Facility: Columbia Regional Airport

Address: 11300 S. Airport Drive Date of Survey: 01/05/10

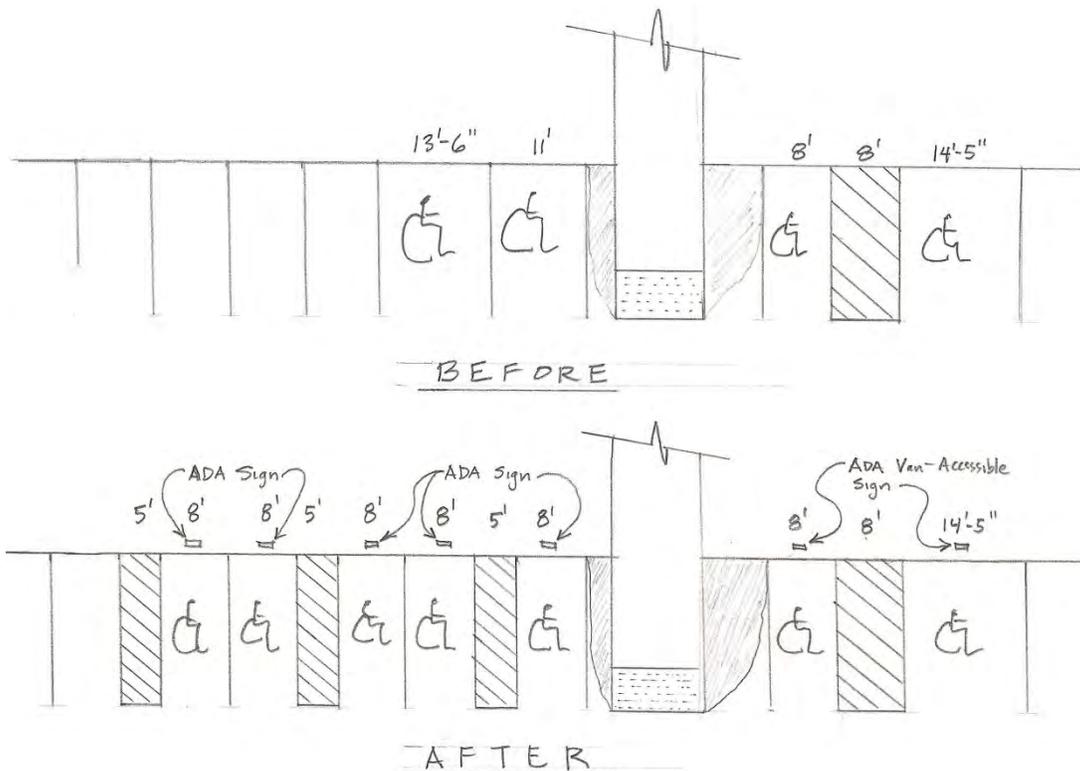
- Refer to site plan included with this report: (1) There are two ADA parking spaces located just north of the access walk in the parking lot. These spaces do not have the required access aisle, but the slopes are acceptable. Also recommend adding the three additional ADA parking spaces in this area (see sketch on next page for proposed layout). Restripe (with blue paint) the existing and new parking spaces and related access aisles as shown in the sketch, raise the existing ADA parking signs and install new ADA parking signs in locations shown in sketch (signs to be 72" above grade).
